HISTORIC AND DESIGN REVIEW COMMISSION

HDRC CASE NO: 2022-303
ADDRESS: 226 E HUISACHE AVE
LEGAL DESCRIPTION: NCB 3086 BLK 2 LOT 7
ZONING: R-4 CD, H
CITY COUNCIL DIST.: 1
DISTRICT: Monte Vista Historic District
APPLICANT: Nadav Givoni/GR-226 HUISACHE LLC
OWNER: Nadav Givoni/GR-226 HUISACHE LLC
TYPE OF WORK: Window replacement
APPLICATION RECEIVED: May 01, 2022
60-DAY REVIEW: Not applicable due to City Council Emergency Orders
CASE MANAGER: Hannah Leighner
REQUEST:

The applicant is requesting a Certificate of Appropriateness for approval to replace nineteen (19) existing wood windows with new wood windows.

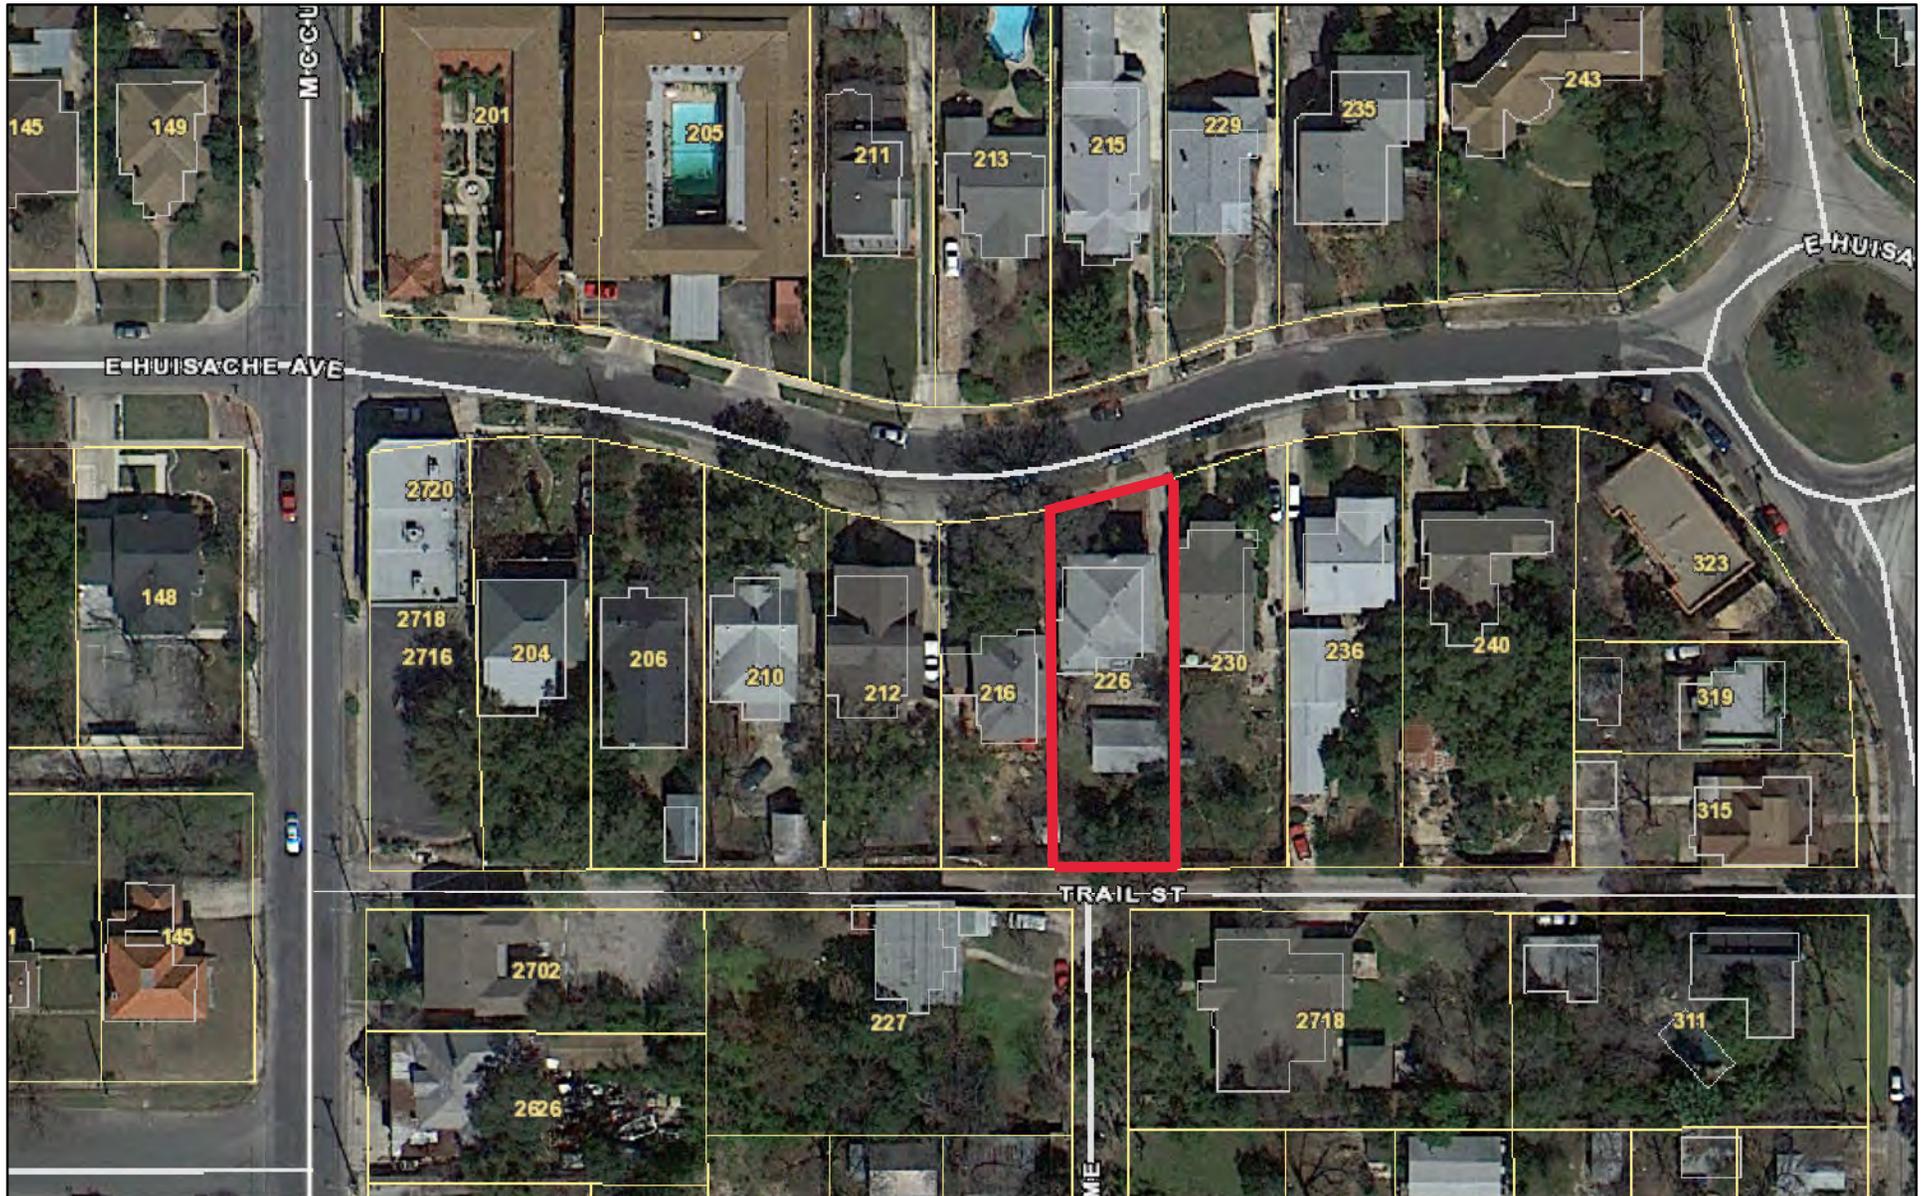
- a. The property located at 226 E Huisache is a two-story, single family, Italianate structure featuring stucco cladding, one-over-one windows and Romanesque-style arches over two front doors and a centered chimney. The house contributes to the Monte Vista Historic District.

- c. **WINDOW REPLACEMENT: EXISTING CONDITION** – From the photos submitted to date, the wood windows proposed for replacement appear to be of historic-age, fully wood one-over-one windows. The windows do not show signs of significant wood rot, wood damage, or severe deterioration. Staff finds that the wood windows are in repairable condition based on the documentation provided, with most requiring minimal repair and intervention such as the reworking of the sashes and re-glazing, along with refitting into the trim and frames. Staff has scheduled a site visit with the applicant for Monday, May 30 and may be able to report additional information at the hearing.

Staff does not recommend approval based on findings b – e. Staff recommends that the applicant restore the deteriorated wood windows and preserve all original window openings. If the HDRC is compelled to approve window replacement, staff recommends the following stipulations:

4 WEST ELEVATION
SCALE 1/4"=1'-0"

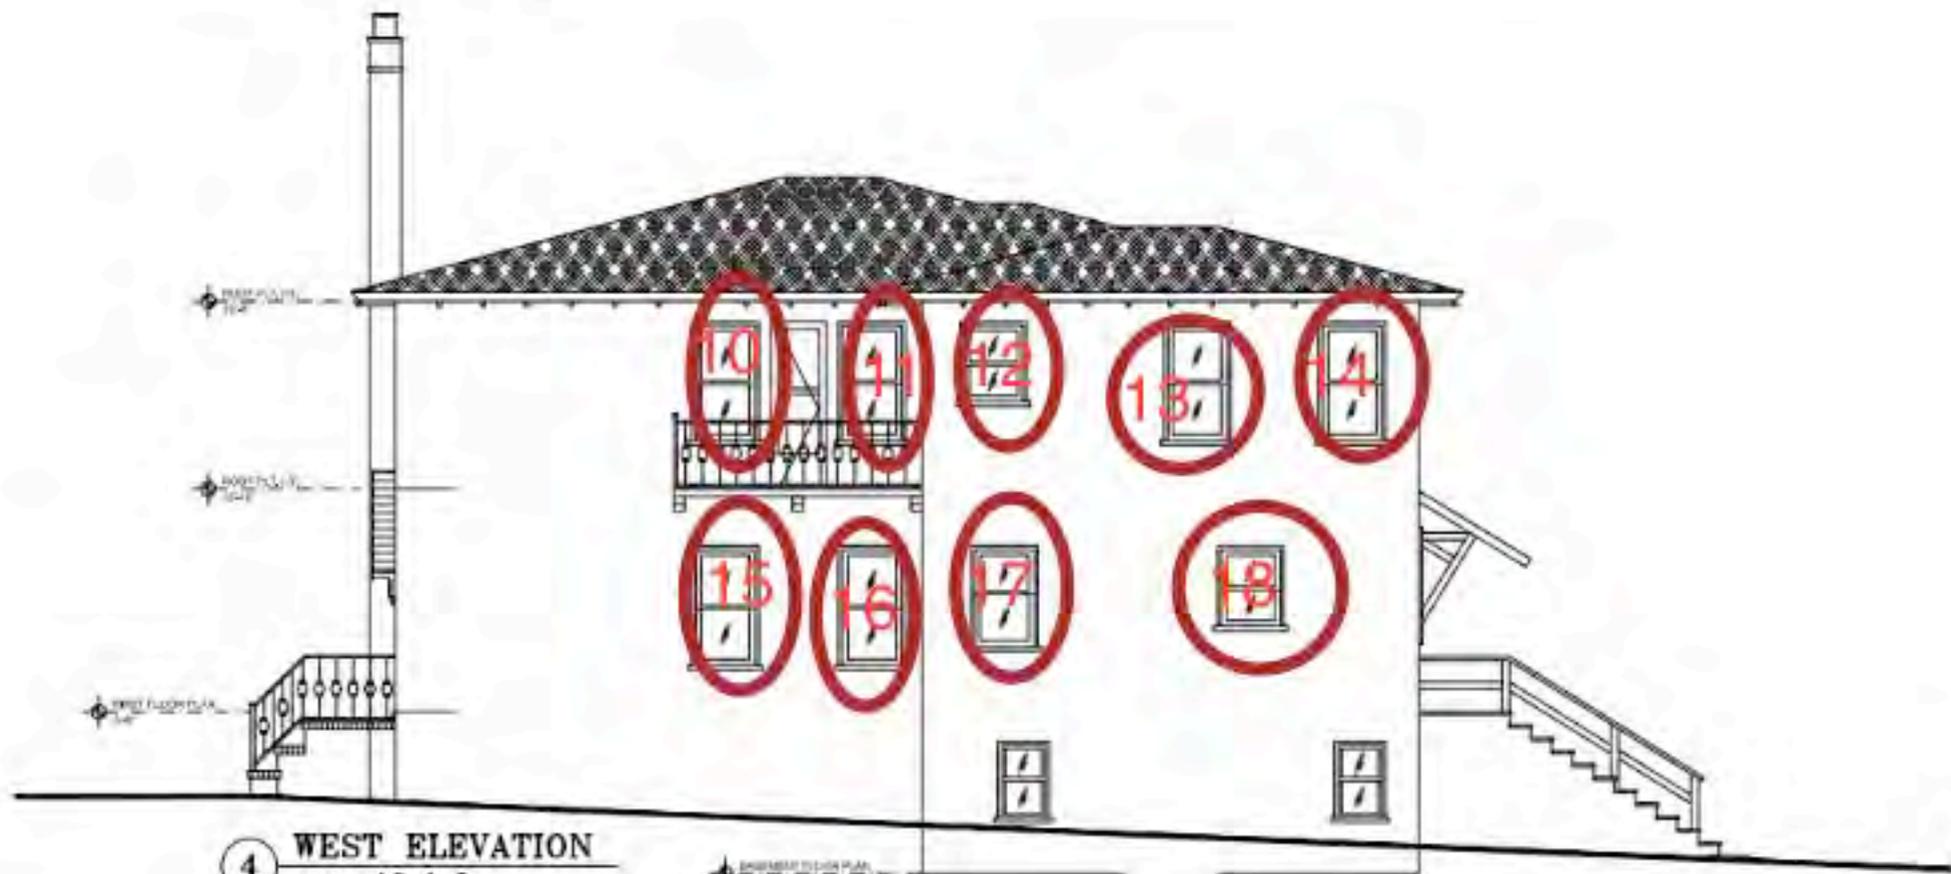
- b. **WINDOW REPLACEMENT: WOOD WINDOWS** – The applicant has proposed to replace nineteen (19) existing wood windows with replacement wood windows. The windows requested for replacement are located on the north, south, east, and west elevations. According to the Historic Design Guidelines, wood windows should be repaired in place and restored whenever possible, unless there is substantial evidence that the windows are deteriorated beyond repair. Guideline 6.B.iv for Exterior Maintenance and Alterations states that new windows should be installed to match the historic or existing windows in terms of size, type, configuration, material, form, appearance, and detail when original windows are deteriorated beyond repair.

- i. **MATERIALS:** If full window replacement is approved, the new windows must feature primed and painted wood exterior finish. Clad, composition, or non-wood options are not allowed unless explicitly approved by the commission.

- ii. **SASHES:** Meeting rails must be no taller than 1.25". Stiles must be no wider than 2.25". Top and bottom sashes must be equal in size unless otherwise approved.

- iii. **DEPTH:** There should be a minimum of 2" in depth between the front face of the window trim and the front face of the top window sash. This must be accomplished by recessing the window sufficiently within the opening or with the installation of additional window trim to add thickness.
